Contract #: 04-0120F4
 Cty: SF/ALA Rte: 80 PM: 13.2/13.9
 File #: 69.25B

QUALITY ASSURANCE -- NON-CONFORMANCE REPORT

Location: Changxing Island, Shanghai, P.R. China **Report No:** NCR-000900
Prime Contractor: American Bridge/Fluor Enterprises, a JV **Date:** 23-Nov-2010
Submitting Contractor: Zhenhua Port Machinery Company, Ltd (ZPMC), Changxing Island **NCR #:** ZPMC-0862

| Procedural | Procedural | Description: Lift 4 Tower Facade Plate | |

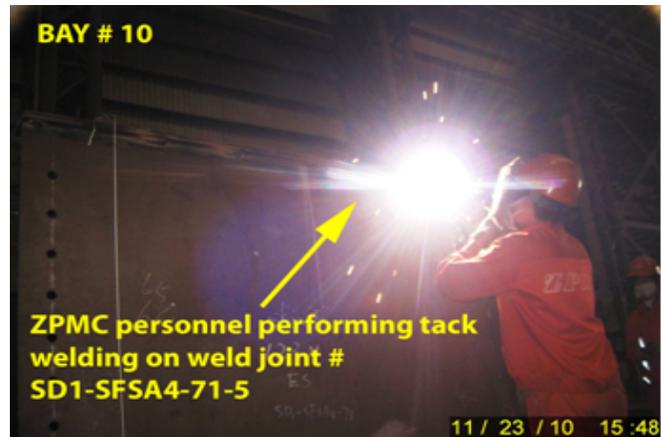
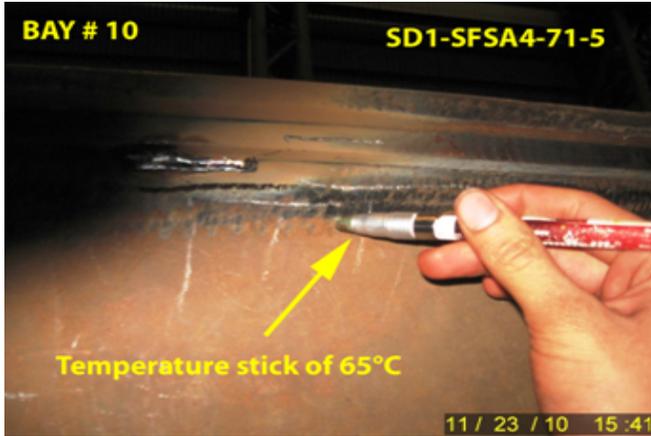
During Caltrans QA in process observations of the fabrication of SD1-SFSA4-71, the QA discovered the following issue:

ZPMC welding personnel did not appear to be following the WELD PROCEDURE REQUIREMENTS FOR NEW WELDS (Rager/ McQuaid), i.e. Preheat shall be applied in such a manner to provide a minimum temperature in the area of the weld of 165 degree Celsius.

- The weld is identified as: SD1-SFSA4-71-5
- The welding process used was SMAW
- The area was being preheated using torch
- The weld is as Fillet joining top plate to side plate
- The component is not SPCM
- The component (SD1-SFSA4-71_ is located in Bay 10.

Reference Resolution: he "NEW WELD PROCEDURE (Rager/McQuaid)" quoted as the basis for this NCR is not a contact document only a recommendation from the QA/QC Committee.

We understand your response. However, successful NDT will close this NCR.

There are no records for issued green tags on these components. Please submit the NDT reports in order to close out this NCR.

Please submit the NDT reports in order to close out this NCR.

This proposed resolution is acceptable. The documentation received is sufficient and the Department concurs that Non-Conformance ZPMC-0862 is closed.

Welding **Concrete** **Other**
Welding **Curing** **Procedural** **Bridge No:** 34-0006
Joint fit-up **Coating** **Other** **Component:** Tower Facade Plate
Procedural **Procedural** **Description:** Lift 4 Tower Facade Plate

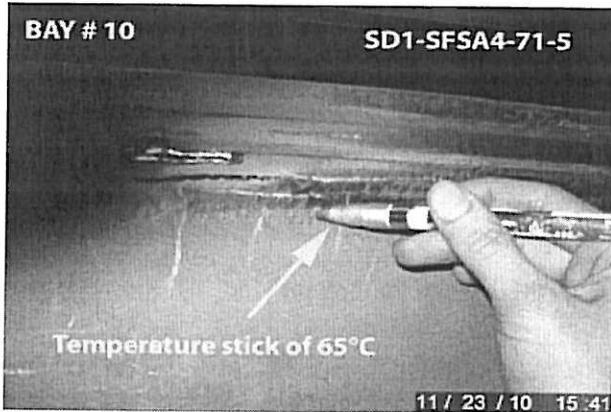
During Caltrans QA in process observations of the fabrication of SD1-SFSA4-71, the QA discovered the following issue:

ZPMC welding personnel did not appear to be following the WELD PROCEDURE REQUIREMENTS FOR NEW WELDS (Rager/ McQuaid), i.e. Preheat shall be applied in such a manner to provide a minimum temperature in the area of the weld of 165 degree Celsius.

- The weld is identified as: SD1-SFSA4-71-5
- The welding process used was SMAW
- The area was being preheated using torch
- The weld is as Fillet joining top plate to side plate
- The component is not SPCM
- The component (SD1-SFSA4-71_ is located in Bay 10.

Component: East Tower Lift 6 Skin plate F

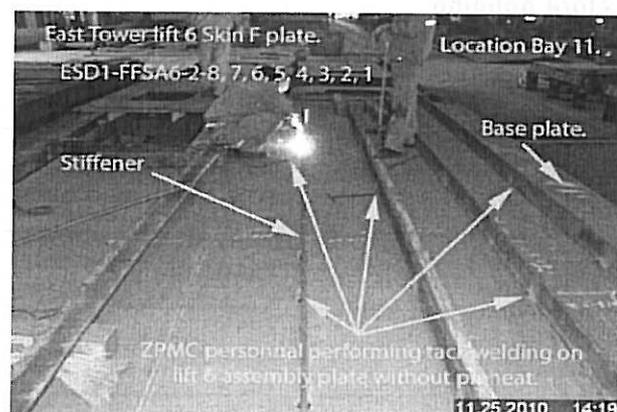
During Caltrans QA in process observations of the fabrication of ESD1-FFSA6-2, the QA discovered the following issue:

ZPMC welding personnel did not appear to be following the WELD PROCEDURE REQUIREMENTS FOR NEW WELDS (Rager/ McQuaid), i.e. Preheat shall be applied in such a manner to provide a minimum temperature in the area of the weld of 165 degree Celsius.

-The welds are identified as: ESD1-FFSA6-2-1, 2, 3, 4, 5, 6, 7, 8.

-The welding process used was SMAW

-The area was not preheated.

-The welds are Fillet Welds joining stiffener plates to skin plate
